ARIZONA DEPARTMENT OF TRANSPORTATION
ROADWAY ENGINEERING GROUP
OFFICE MEMO

RE: Revisions to Construction Standards - Metric Version

RE: ERRATA SHEET - METRIC

DESIGN APPROVED: Terry H. Otterman	STATE OF ARIZONA DEPARTMENT OF TRANSPORTATION INTERMODAL TRANSPORTATION DIVISION STANDARD DRAWINGS	REV. 5/97
APPROVED FOR DISTRIBUTION: [signature]	(1) CATCH BASIN, TYPE 1	DRAWING NO. C-15.10

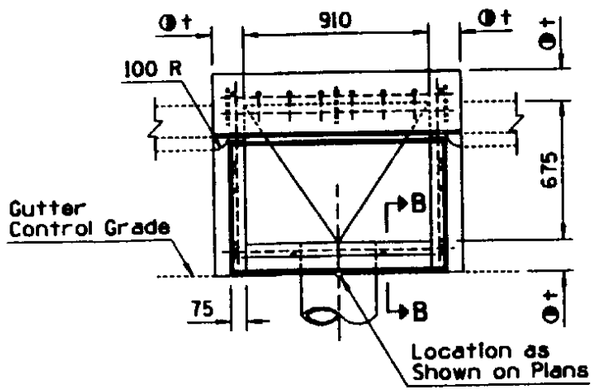
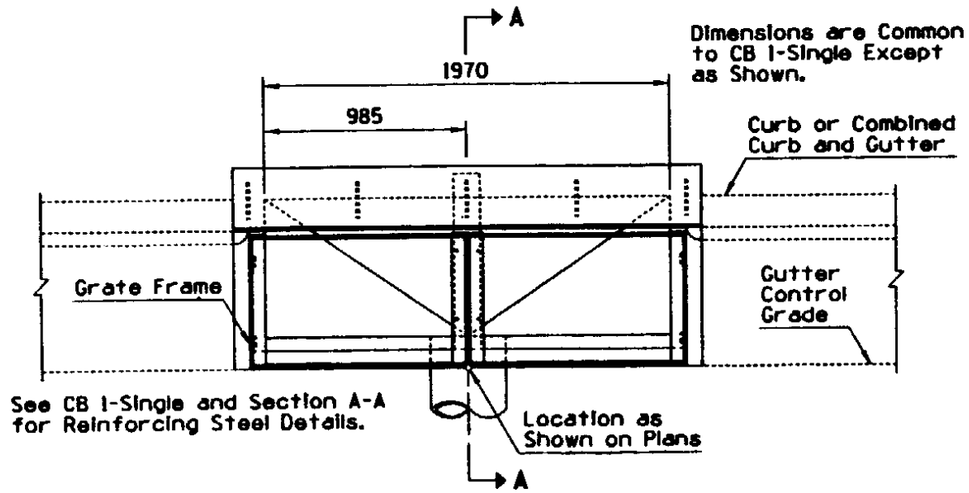
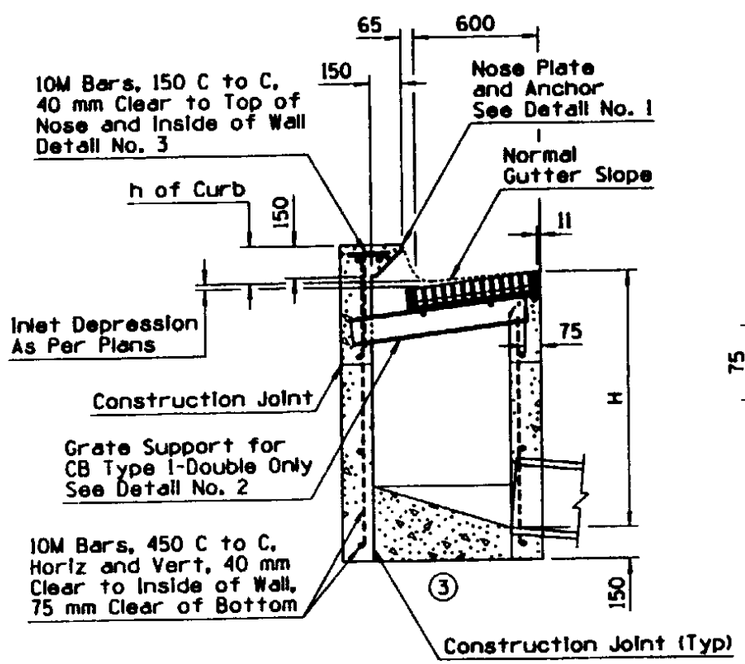
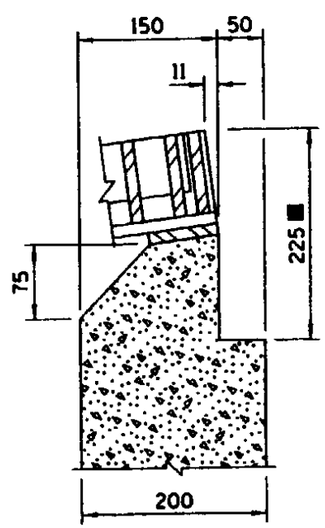
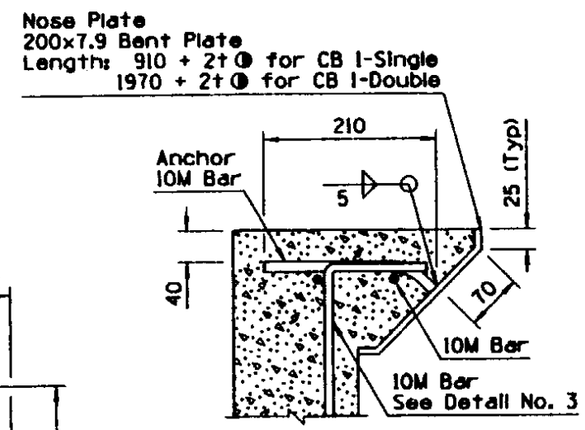
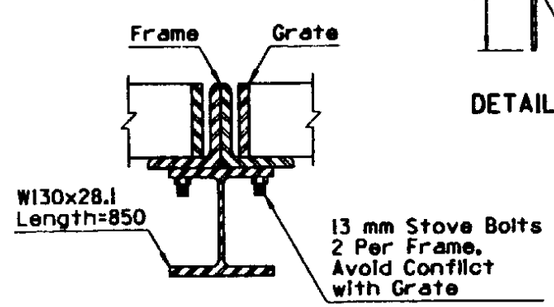
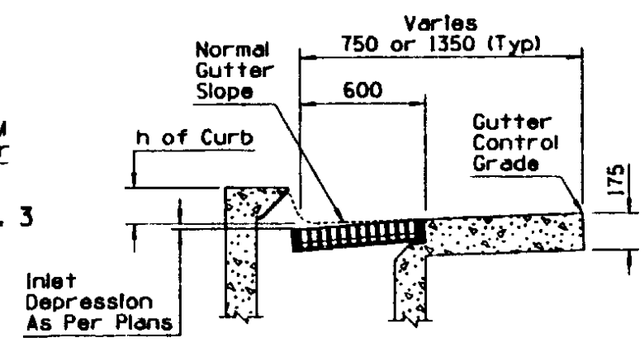
NO	DESCRIPTION OF REVISIONS	MADE BY	DATE
1	REVISED STD FOR NEW FRAME AND NOSE PLATE	PNB	5/97
2	REVISED DETAIL	PNB	5/97
3	REVISED FLOOR FOR POURING AFTER WALLS	PNB	5/97
4	ADDED DETAIL OR NOTE	PNB	5/97

DESIGN APPROVED	STATE OF ARIZONA DEPARTMENT OF TRANSPORTATION INTERMODAL TRANSPORTATION DIVISION STANDARD DRAWINGS	REV. 5/97
APPROVED FOR DISTRIBUTION	1 2 CATCH BASIN, TYPE 3	DRAWING NO. C-15.20 Sheet 1 of 2

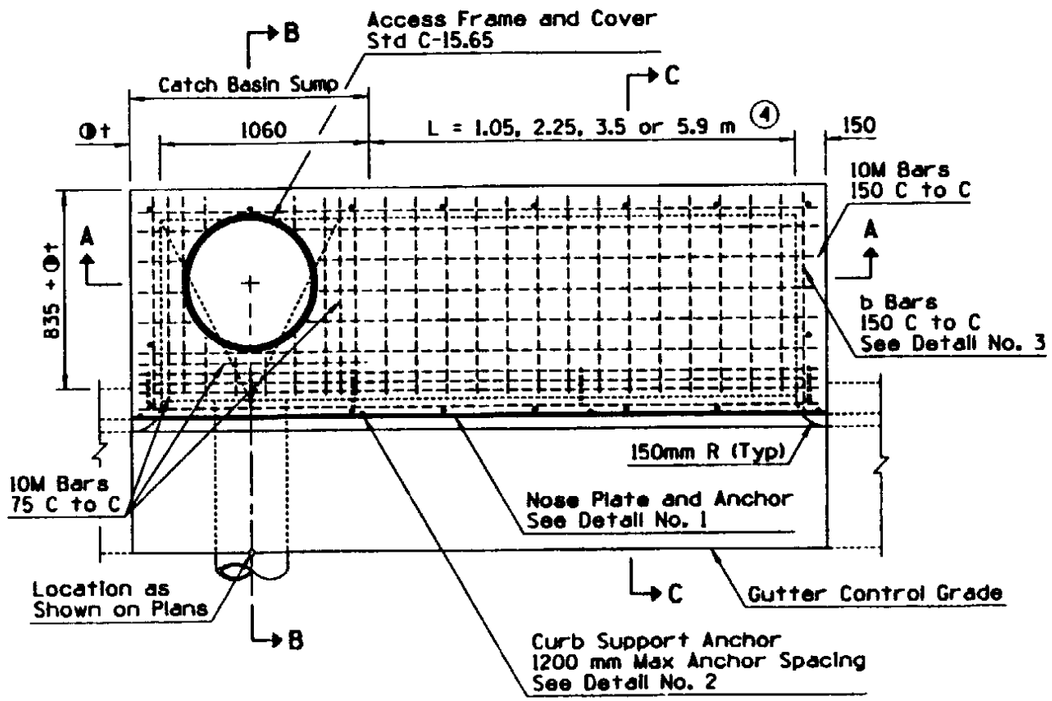
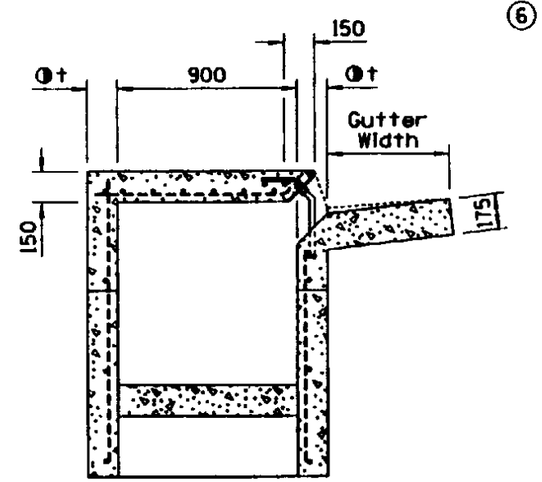
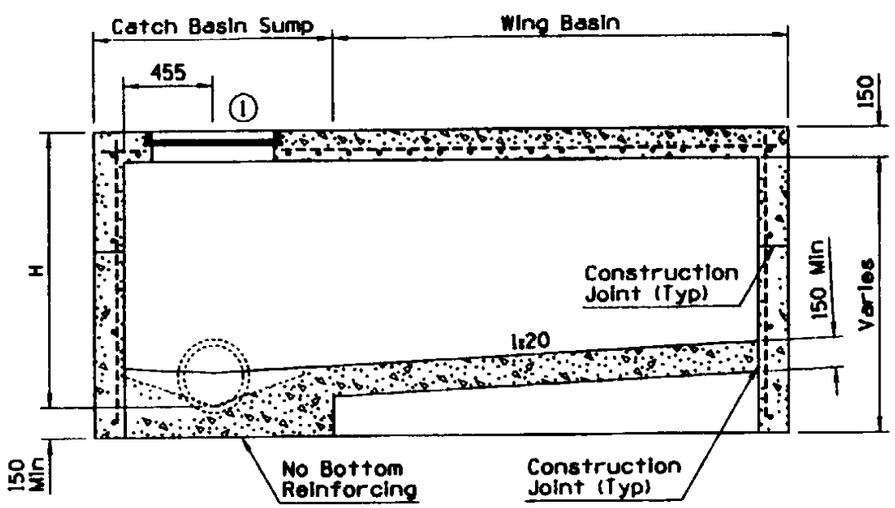
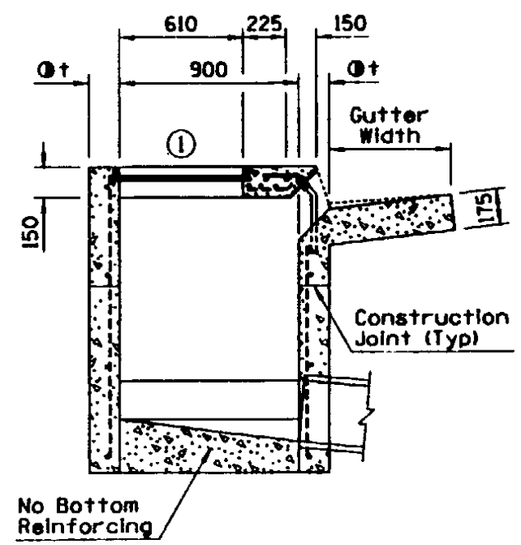
NO	DESCRIPTION OF REVISIONS	MADE BY	DATE
1	REVISED STD FOR NEW ACCESS FRAME AND COVER	PNB	5/97
2	ADDED SHEETS FOR REVISED DETAILS	PNB	5/97
3	REVISED SECTION	PNB	5/97
4	REVISED LENGTHS OF WINGS	PNB	5/97
5	ADDED SECTION	PNB	5/97
6	CONSOLIDATED NOTES	PNB	5/97
7	ADDED NOTE	PNB	5/97
8

DESIGN APPROVED	STATE OF ARIZONA DEPARTMENT OF TRANSPORTATION INTERMODAL TRANSPORTATION DIVISION STANDARD DRAWINGS	REV. 5/97
APPROVED FOR DISTRIBUTION	(1) CATCH BASIN, TYPE 4	DRAWING NO. C-15.30

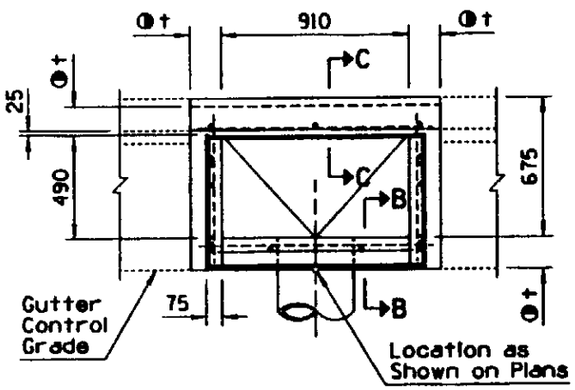
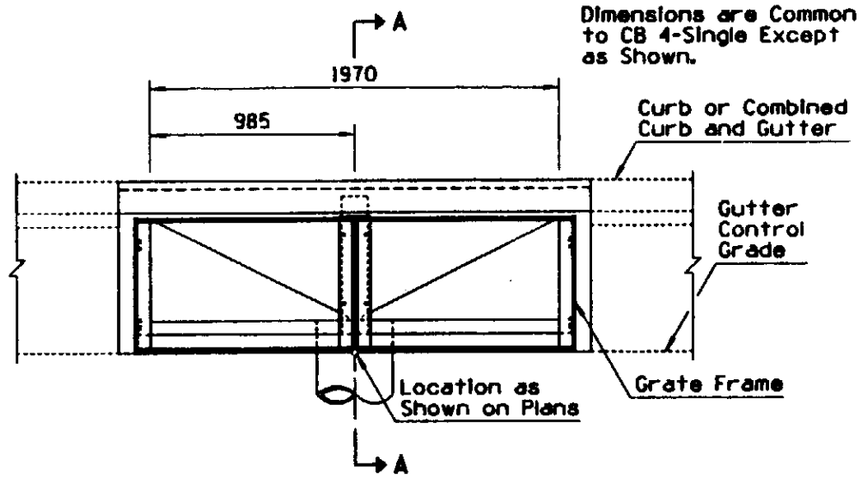
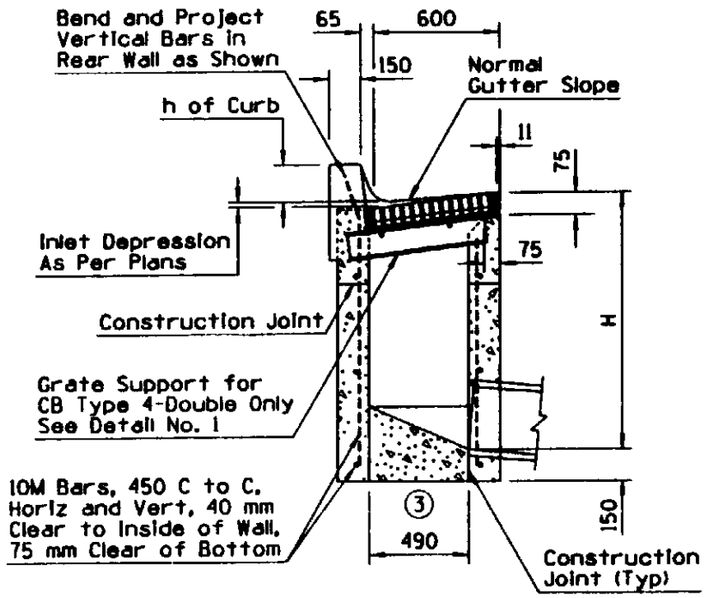
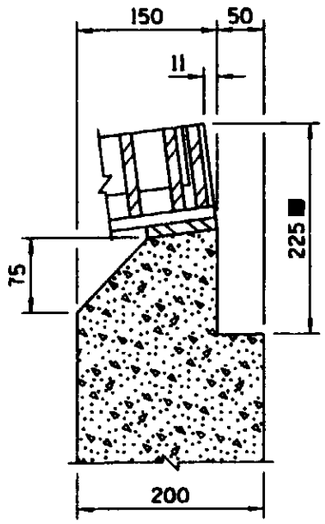
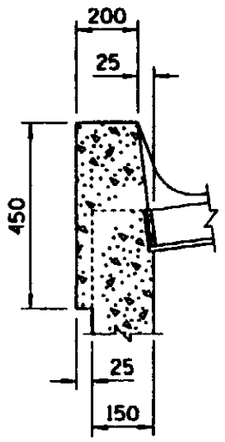
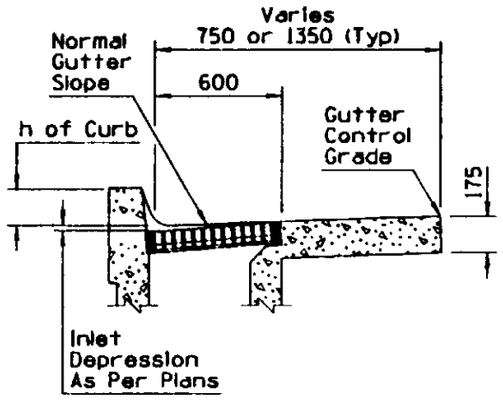
NO	DESCRIPTION OF REVISIONS	MADE BY	DATE
1	REVISED STD FOR NEW FRAME	PNB	5/97
2	REVISED DETAIL	PNB	5/97
3	REVISED FLOOR FOR POURING AFTER WALLS	PNB	5/97
4	ADDED SECTION OR DETAIL	PNB	5/97

NO	DESCRIPTION OF REVISIONS	MADE BY	DATE
5	REVISED NOTE	PNB	5/97
6	ADDED NOTE	PNB	5/97
7			
8

DESIGN APPROVED	STATE OF ARIZONA DEPARTMENT OF TRANSPORTATION INTERMODAL TRANSPORTATION DIVISION STANDARD DRAWINGS	REV. 5/97
APPROVED FOR DISTRIBUTION	① ② CATCH BASIN, TYPE 5	DRAWING NO. C-15.40 Sheet 1 of 2

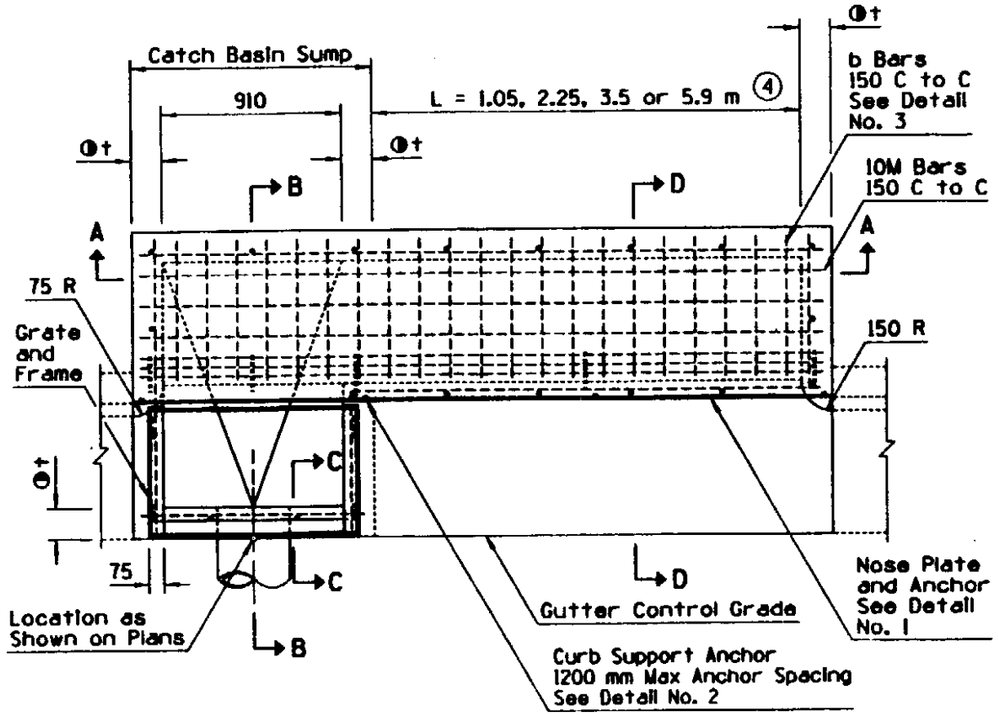
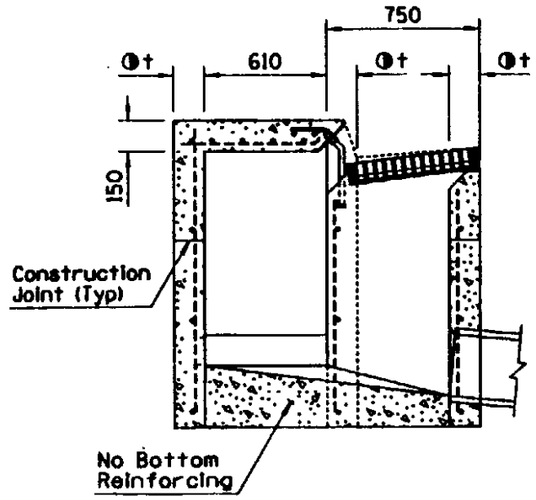
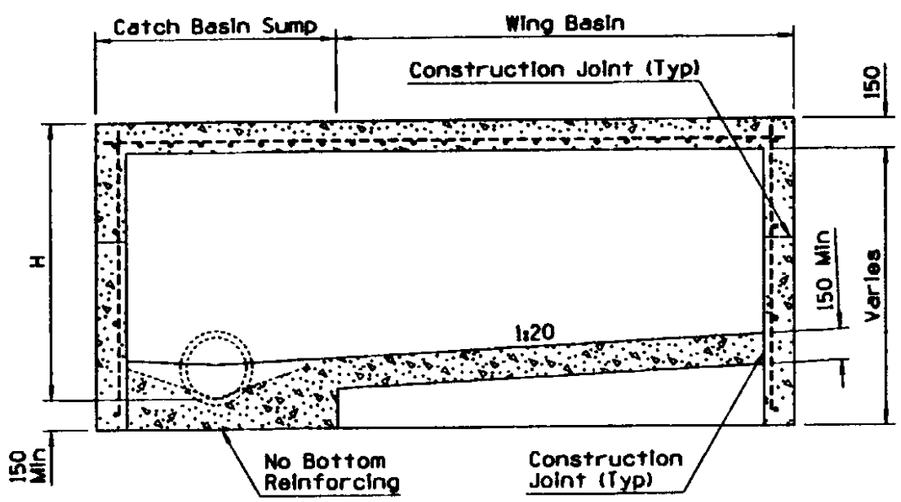
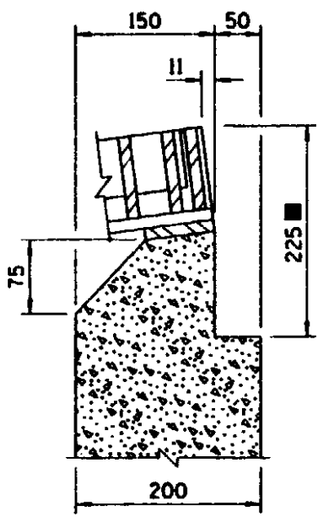
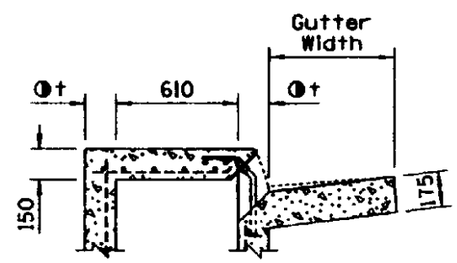
NO	DESCRIPTION OF REVISIONS	MADE BY	DATE
1	MODIFIED STD FOR NEW FRAME AND NOSE PLATE	PNB	5/97
2	ADDED SHEET 2 FOR REVISED DETAILS	PNB	5/97
3	REVISED SECTION	PNB	5/97
4	REVISED LENGTHS OF WINGS	PNB	5/97
5	ADDED SECTION	PNB	5/97
6	REVISED NOTE	PNB	5/97
7	CONSOLIDATED NOTES	PNB	5/97
8	ADDED NOTE	PNB	5/97

DESIGN APPROVED	STATE OF ARIZONA DEPARTMENT OF TRANSPORTATION INTERMODAL TRANSPORTATION DIVISION STANDARD DRAWINGS	REV. 5/97
APPROVED FOR DISTRIBUTION	CATCH BASIN, GRATES	DRAWING NO. C-15.50

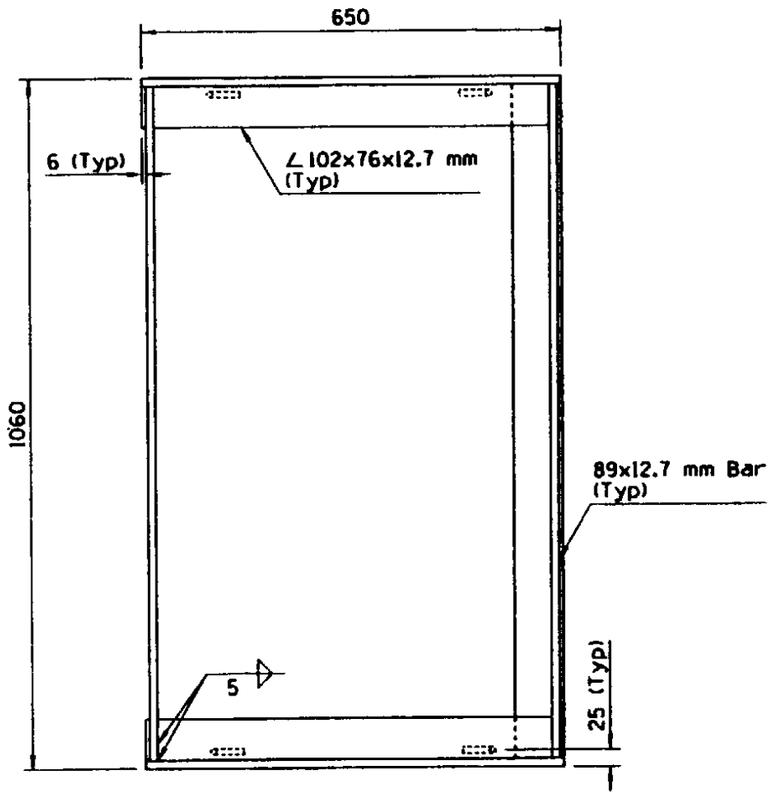
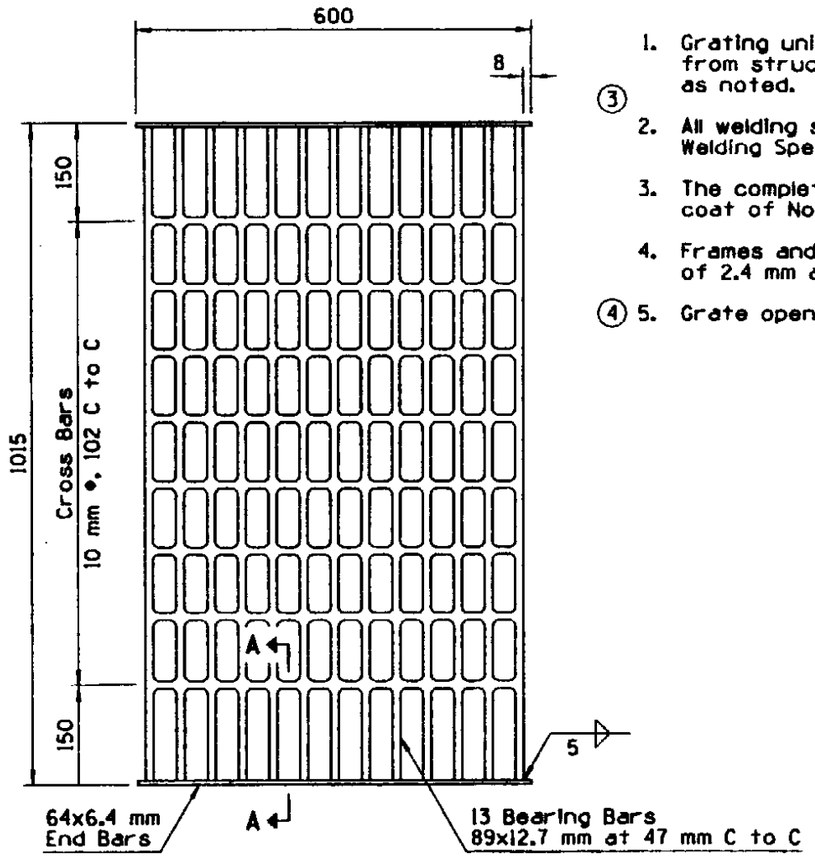
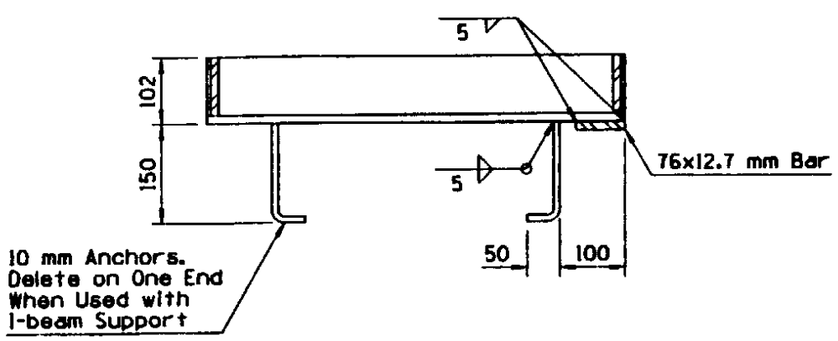
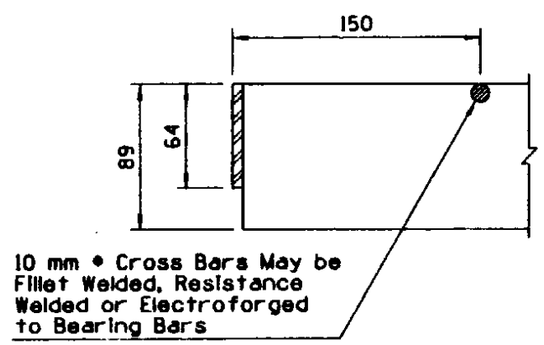
NO	DESCRIPTION OF REVISIONS	MADE BY	DATE
1	DELETED ALL GRATES EXCEPT WIDE EF-1	PNB	5/97
2	DELETED NARROW FRAME	PNB	5/97
3	DELETED THREE GENERAL NOTES	PNB	5/97
4	ADDED GENERAL NOTE	PNB	5/97

DESIGN APPROVED APPROVED FOR DISTRIBUTION	STATE OF ARIZONA DEPARTMENT OF TRANSPORTATION INTERMODAL TRANSPORTATION DIVISION STANDARD DRAWINGS	REV. 5/97
	① CATCH BASIN MISC. DETAILS	DRAWING NO. C-15.70 Sheet 1 of 2

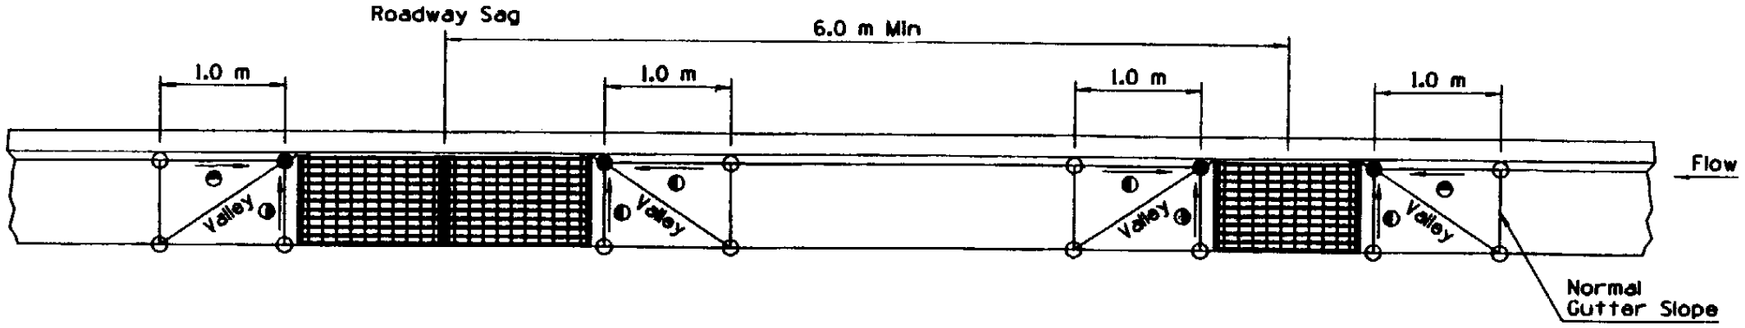
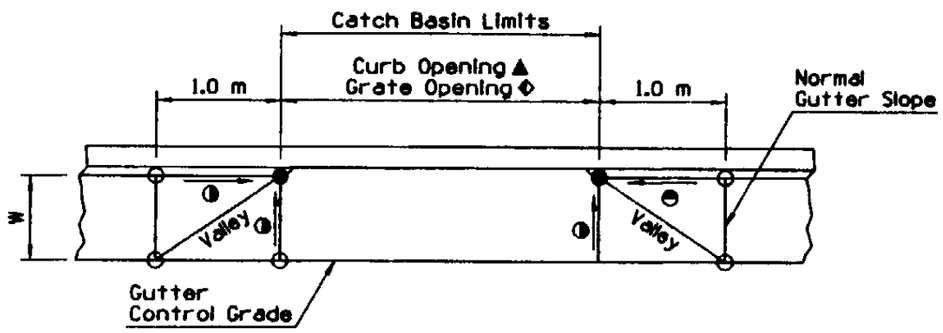
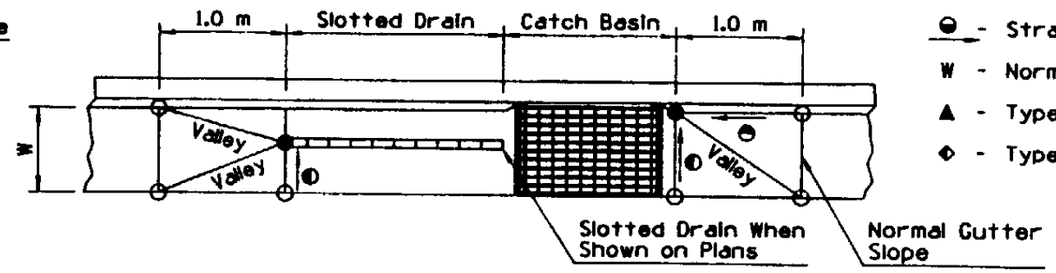
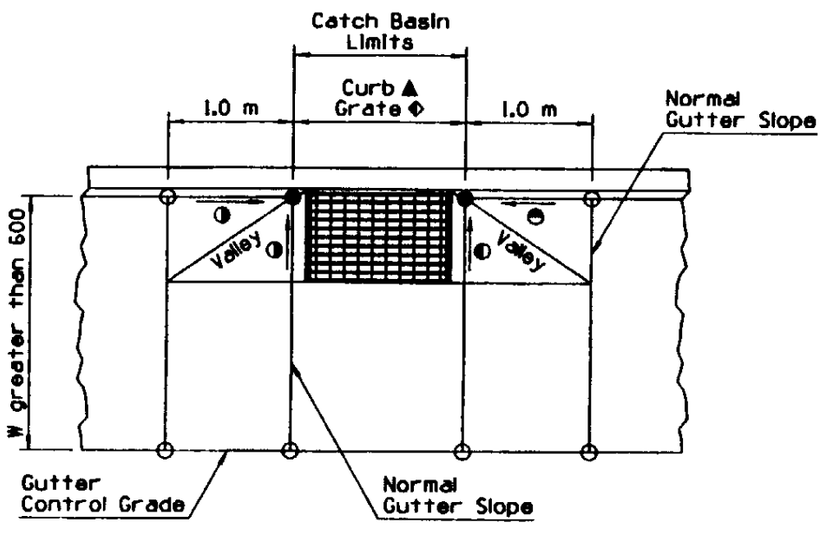
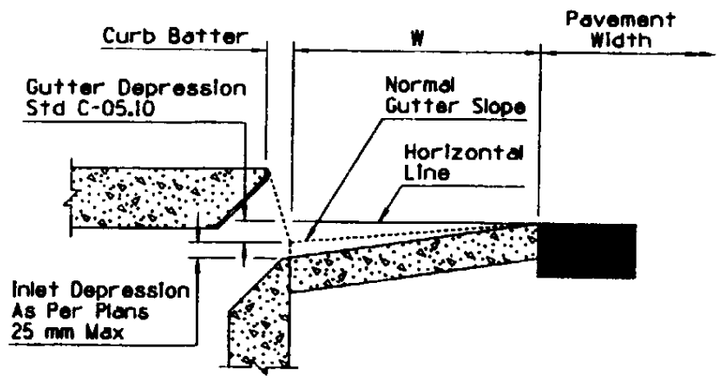
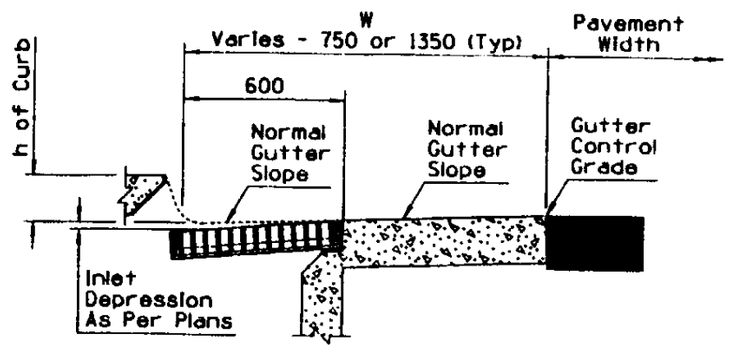
NO	DESCRIPTION OF REVISIONS	MADE BY	DATE
1	REVISED STD FOR NEW FRAME	PNB	5/97
2	ADDED DETAIL TO SHOW WIDE GUTTER	PNB	5/97
3	REVISED NOTE	PNB	5/97
4
